Section 92 - Further information response

Please find below responses to the s92 requests.

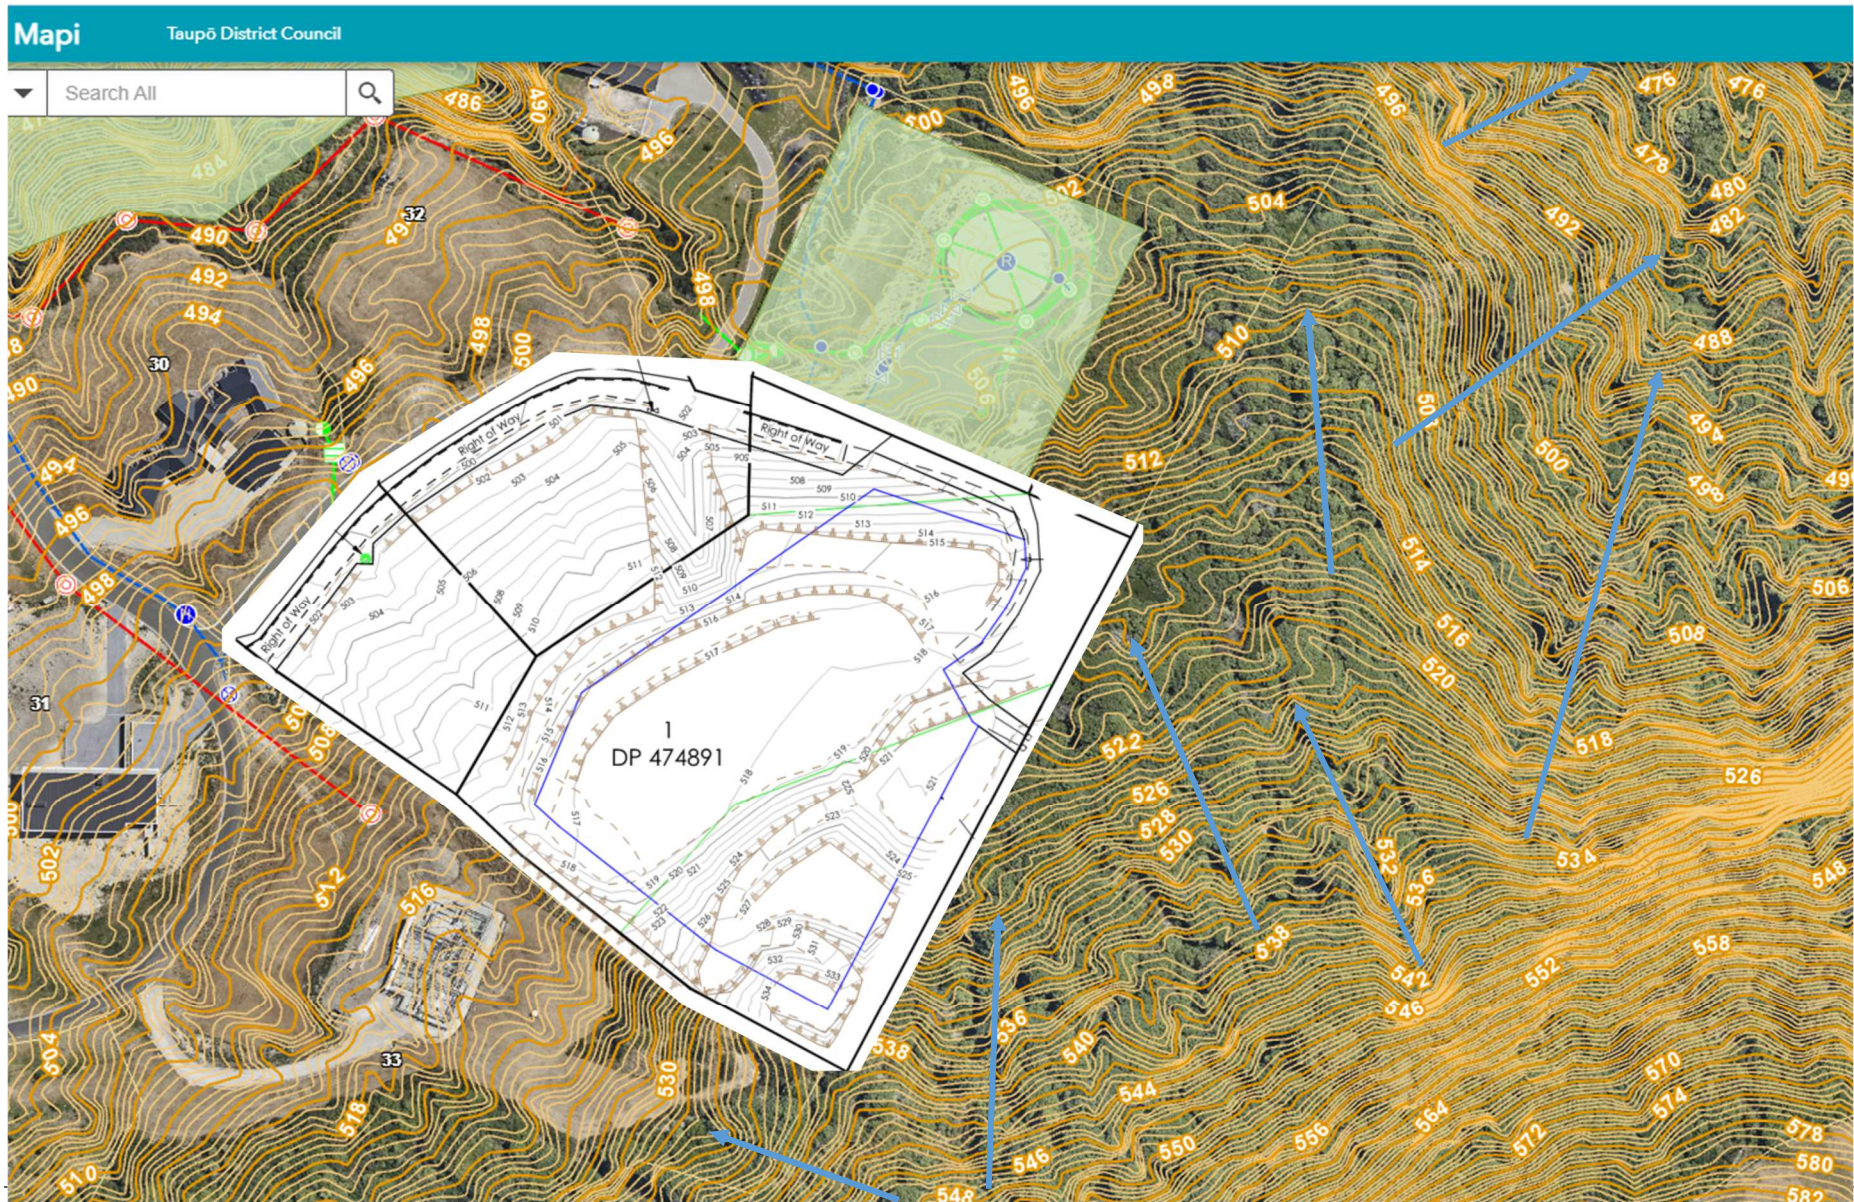
4. *An upper catchment diversion for the slope above the works area was also discussed during the site visit. If a clean water diversion is not proposed, please indicate the size of the DEB contributing catchments without CWDs.*

5. *There is no proposal for flocculation of the DEBs. Flocculation is now standard best practice for earthworks sites, please justify why there is no flocculation proposed for this site.*

The Clean Water diversion has been extended as shown on SK- 001

Section 2.3.3 – Flocculation Management Plan –added. Flocculation to be used if determined necessary.

Overland flow paths above the site

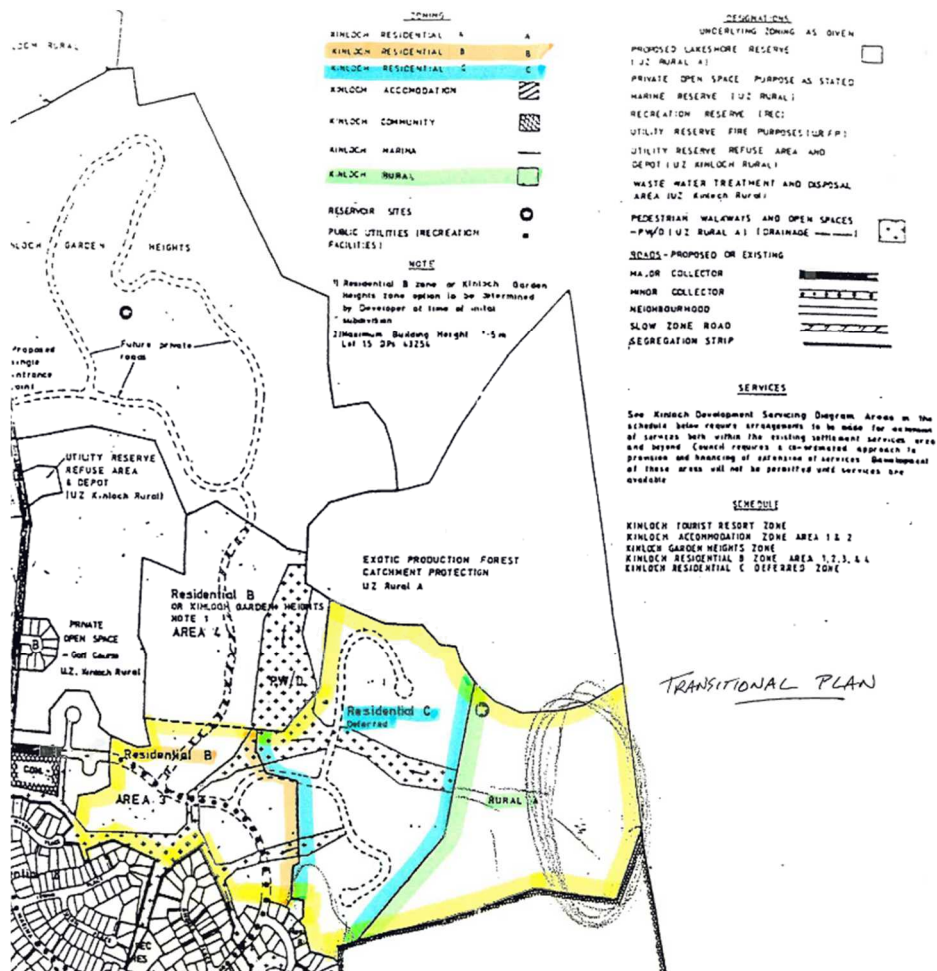
- (b) *Earthworks filling of a gully to the north of the site within No 32 Locheagles Rise is proposed. Please provide details of the current and proposed overland flowpaths across the site and neighbouring sites from the steep catchment above and provide information on any potential downstream effects of filling the gully (along with the general earthworks proposed) in terms of overland flows. This should also show how the proposed dwelling will be protected from possible inundation and update the EMP plan to provide for diverting any clean water flows entering the earthworks site from the catchments above.*

The overland flow paths from the steep and bush covered catchment above already pass around 36 Locheagles Rise. Any overland flow from the steep and bush covered catchment above has a natural flow path which passes to the north-east of 36 Locheagles, and continues down to the northeast of the TDC water reservoir and then to the northeast of 34 Locheagles, before making its way into the bush covered gully to the north.

For overland flows generated on 36 Locheagles itself, the flows will be directed initially to on site soakage. Flow paths exist which pass to the south of the gully within 32 Locheagles and to a cesspit on the access road. The cesspit discharges to the gully between Lots 2 and 3 Locheagles Rise and eventually to the bush gully alongside and to the north of the Locheagles Rise road.

There is so much contour across the entire site, inundation is not possible.
